# UNITED STATES PATENT AND TRADEMARK OFFICE

APPLICATION NO.	FILING DATE	FIRST NAMED INVENTOR	ATTORNEY DOCKET NO.	CONFIRMATION NO.
09/752,651	12/29/2000	Robert C. Glenn	42390P9716	1502

**Office Action Summary**

### DETAILED ACTION

Fig. 6

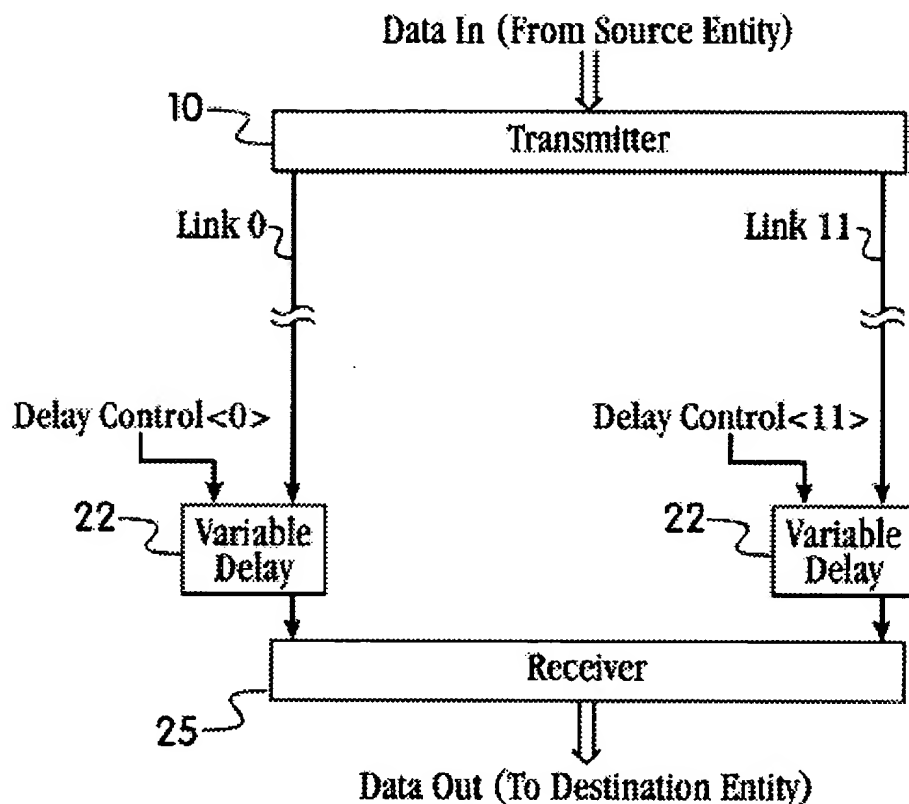
**As per Claims 1-24, Widmer** depicts, e.g., in Fig. 6 and related description in col. 1 line 13 et seq., the claimed method, comprising: a) measuring a skew between a data signal and a clock signal at a receiving end of a serial link; and b) adjusting (col. 2 line 27) a phase relationship between said data signal (col. 2 line 30) and said clock signal (col. 2 line 29) to reduce said skew via variable delay means implementable in hardware or software, e.g., in CPU or other digital component: Refer, e.g., to Fig. 6: block 22 and col. 2 line 23 et seq.

**Widmer** further teaches means to impose delay on one or both signals as seen in Fig. 6. And wherein said adjusting a phase relationship further comprises adjusting a phase offset between a pair of phasors associated with a pair of phase interpolators, a first of said phasors used to derive a second clock signal that times the transmission of said data signal, a second of said phasors used to derive said clock signal in col. 2 line 27 wherein equivalent means are provided for eliminating skews via multiple values of a period to effectively result in phase interpolation means. Also refer to Fig. 6 wherein variable delay blocks 22 are configured to delay signals on the links by more than 360 degrees.
